MOD2020/0049

SCHEDULE OF MODIFICATIONS SOUGHT

PROJECT ADDRESS
98 CUTLER ROAD,
CLONTARF

CLIENT
BOWES HOUSE

1 **01 - Level 1**
 1 : 100

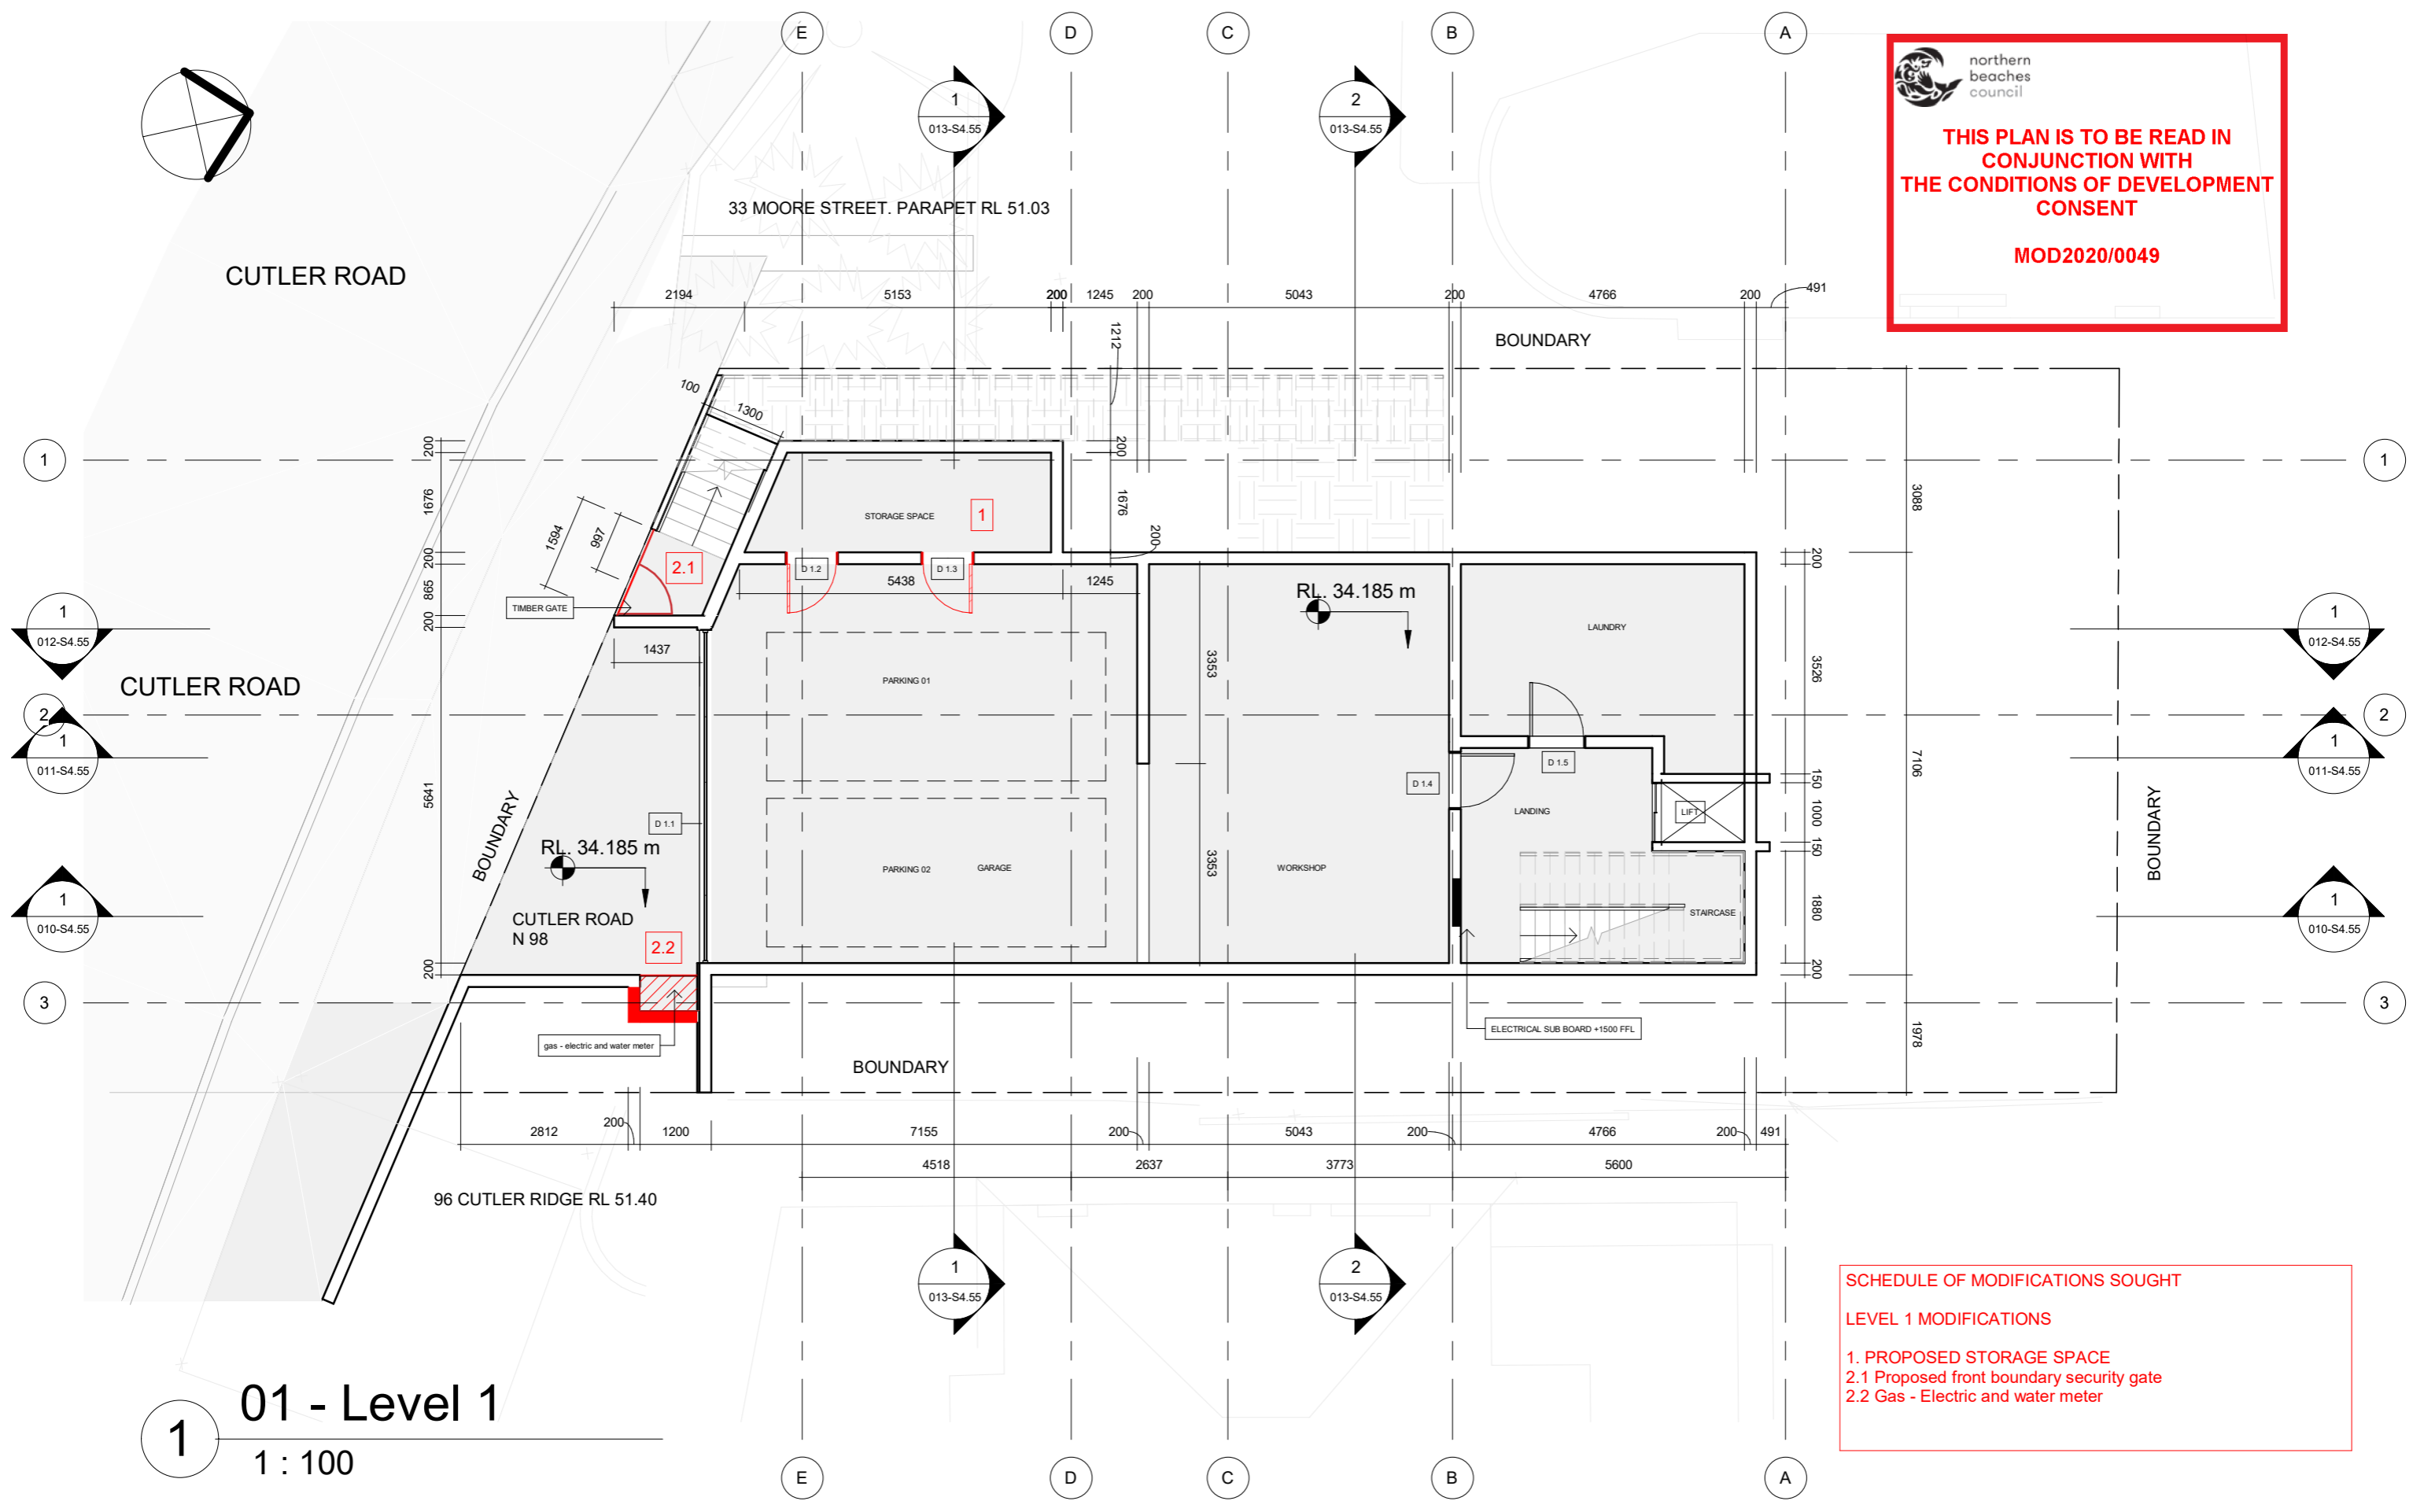
1. PROPOSED STORAGE SPACE
 2.1 Proposed front boundary security gate
 2.2 Gas - Electric and water meter

2 EAST ELEVATION
1 : 100

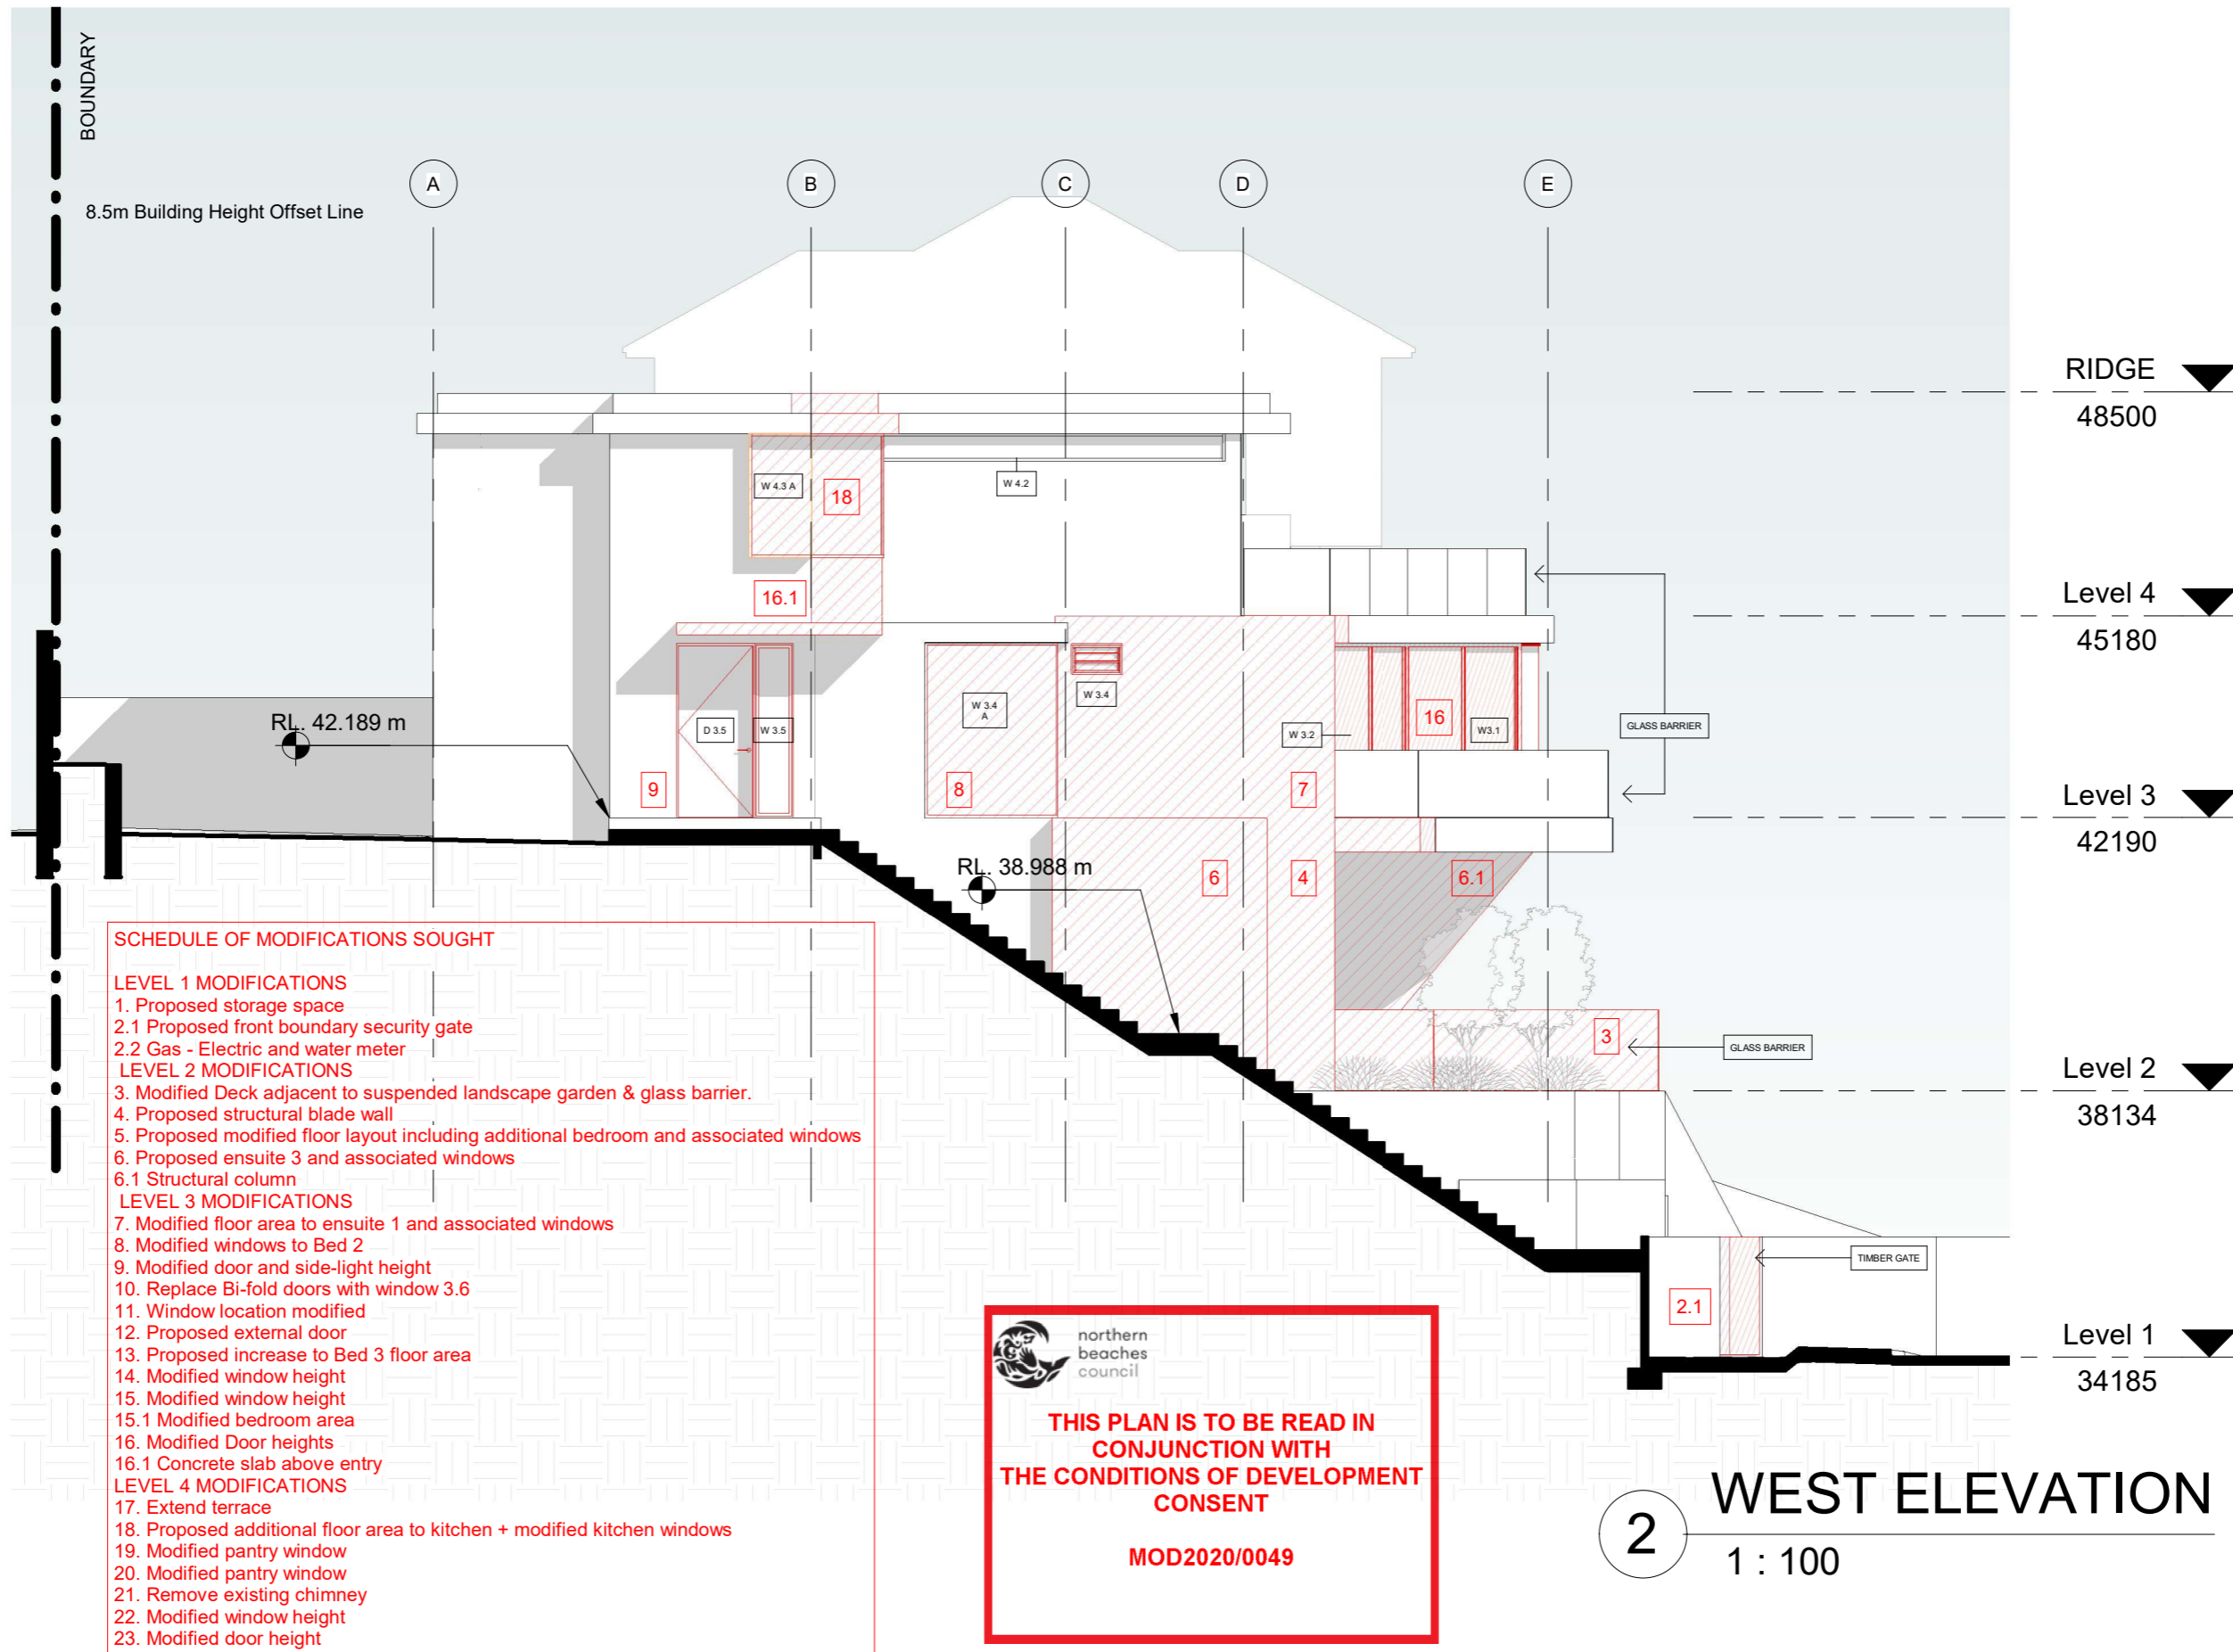
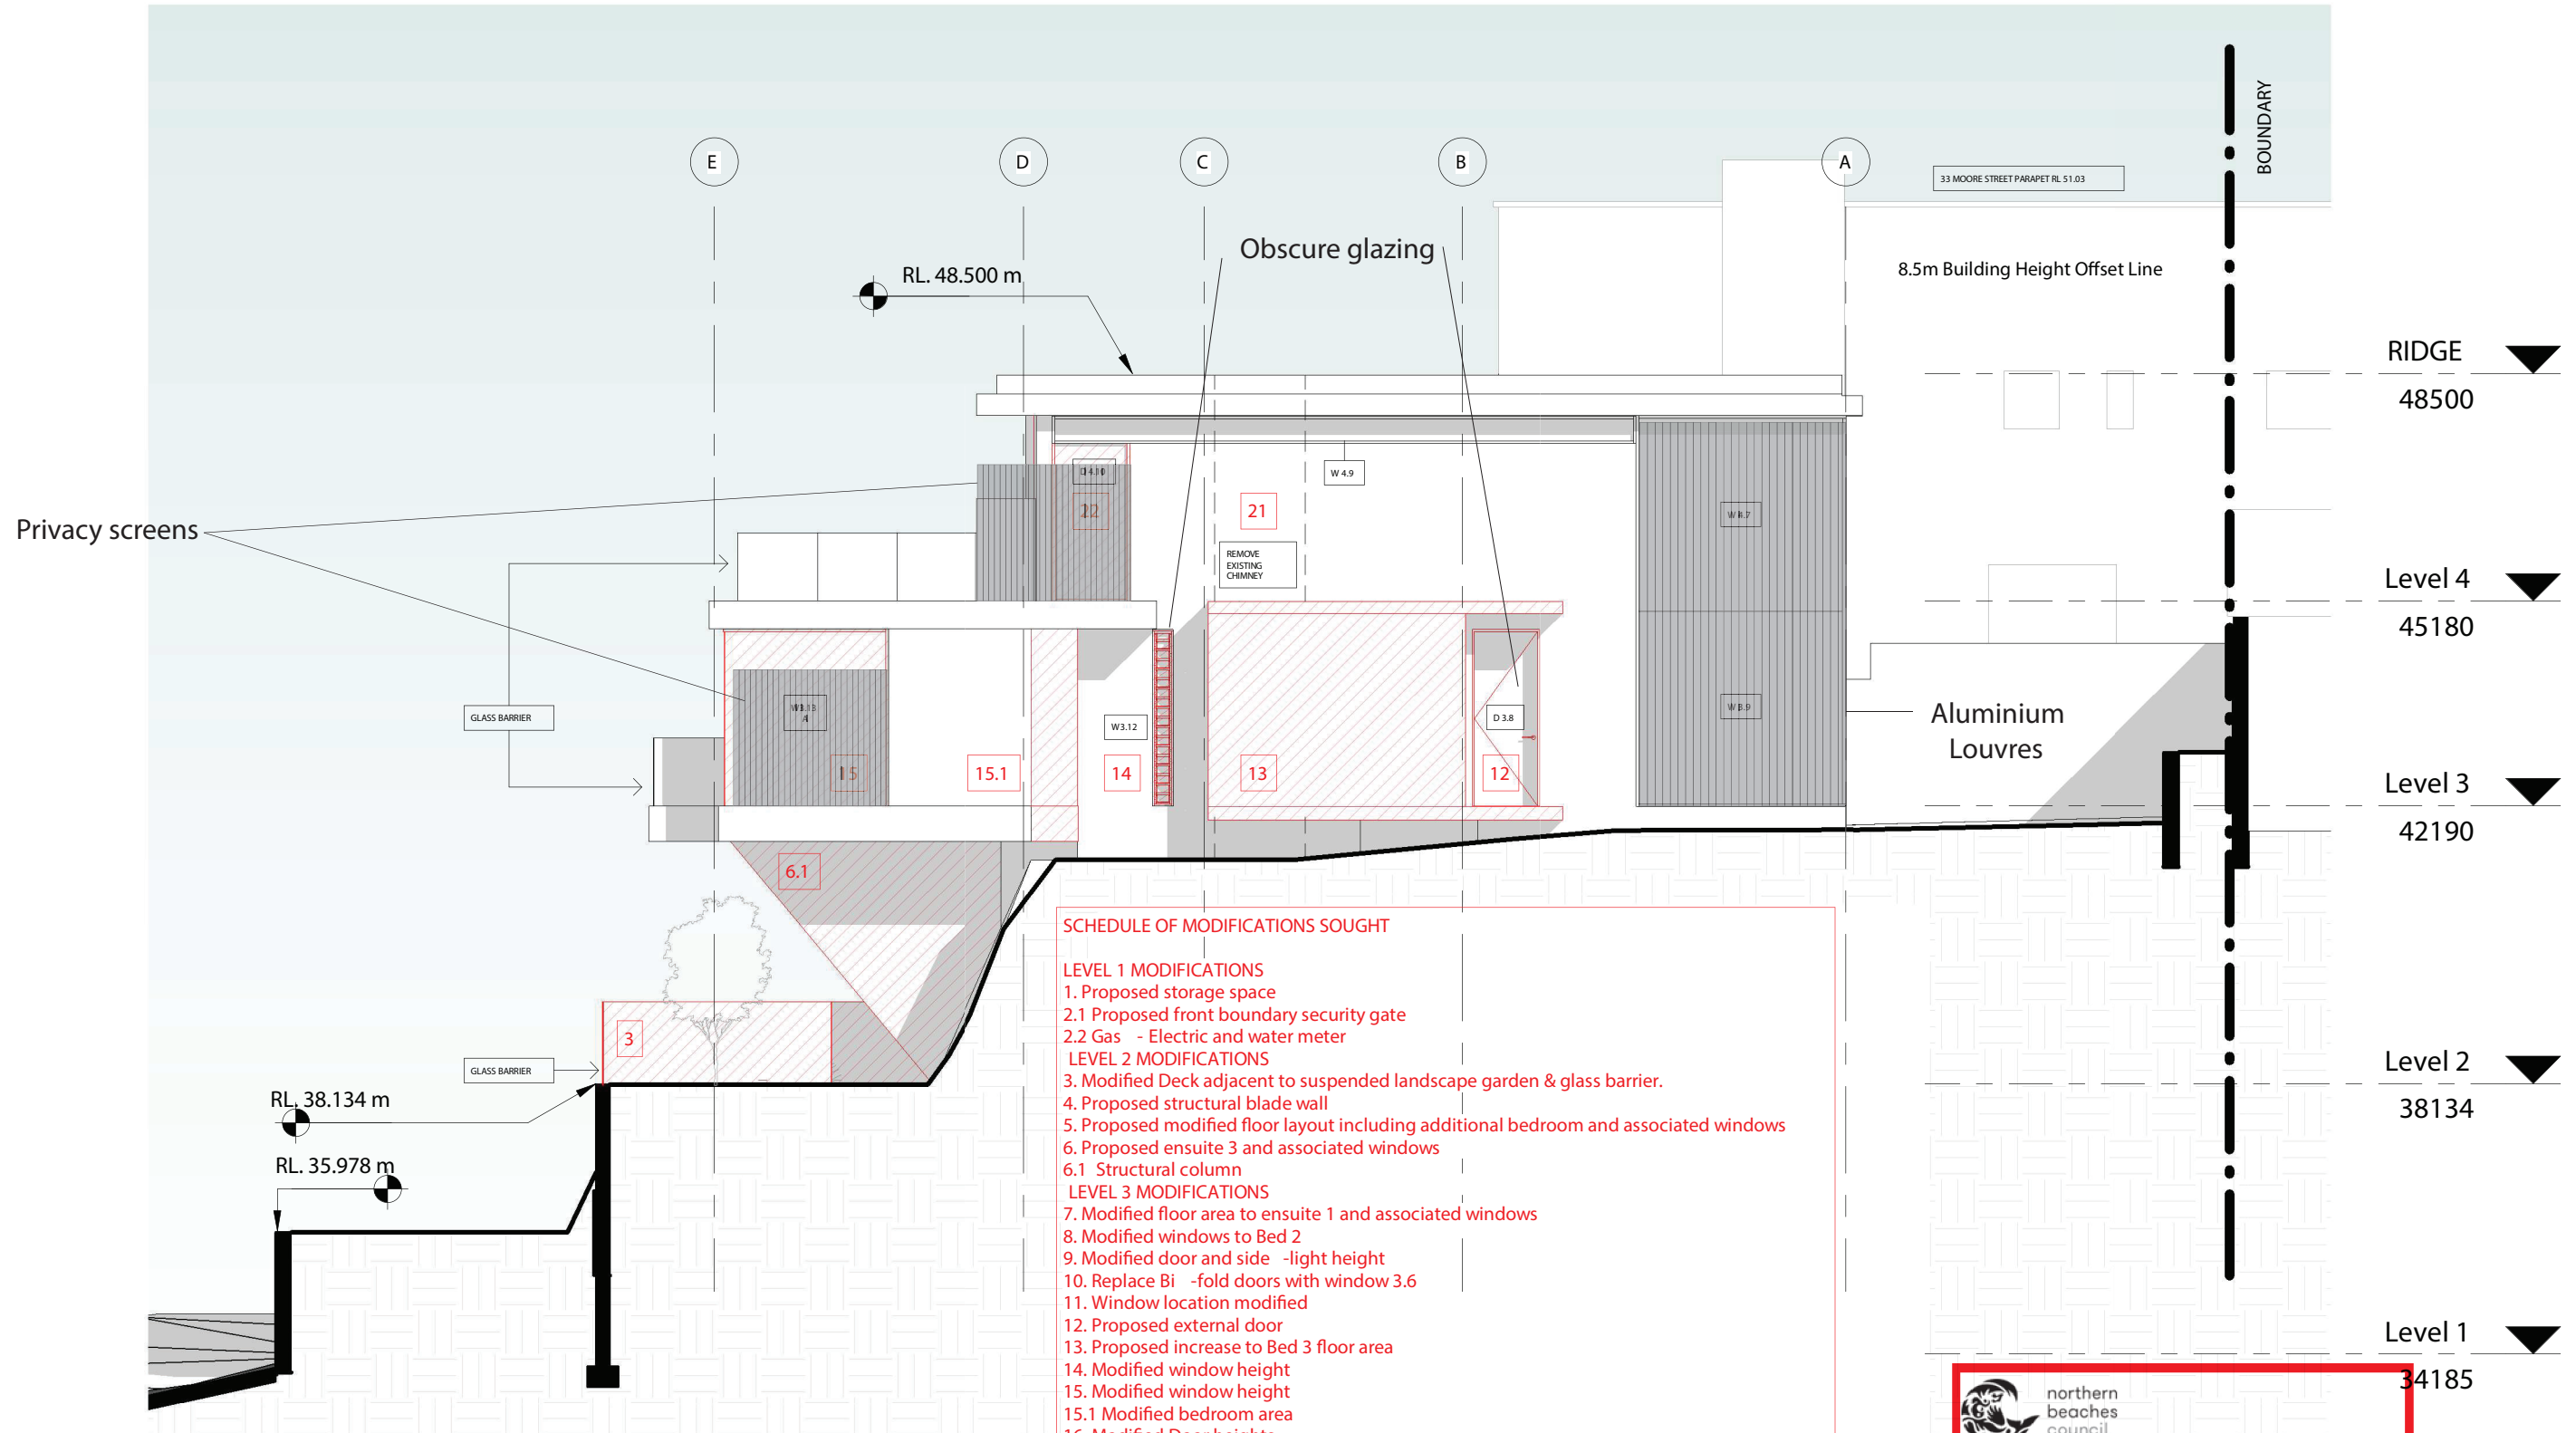
- SCHEDULE OF MODIFICATIONS SOUGHT**
- LEVEL 1 MODIFICATIONS**
- 1. Proposed storage space
 - 2.1 Proposed front boundary security gate
 - 2.2 Gas - Electric and water meter

- LEVEL 2 MODIFICATIONS**
- 3. Modified Deck adjacent to suspended landscape garden & glass barrier.
 - 4. Proposed structural blade wall
 - 5. Proposed modified floor layout including additional bedroom and associated windows

- 6. Proposed ensuite 3 and associated windows
 - 6.1 Structural column
- LEVEL 3 MODIFICATIONS**
- 7. Modified floor area to ensuite 1 and associated windows

- 8. Modified windows to Bed 2
 - 9. Modified door and side -light height
 - 10. Replace Bi -fold doors with window 3.6
 - 11. Window location modified
 - 12. Proposed external door

- 13. Proposed increase to Bed 3 floor area
 - 14. Modified window height
 - 15. Modified window height
 - 15.1 Modified bedroom area
 - 16. Modified Door heights

- 16.1 Concrete slab above entry
- LEVEL 4 MODIFICATIONS**
- 17. Extend terrace
 - 18. Proposed additional floor area to kitchen + modified kitchen windows

- 19. Modified pantry window
 - 20. Modified pantry window
 - 21. Remove existing chimney
 - 22. Modified window height
 - 23. Modified door height
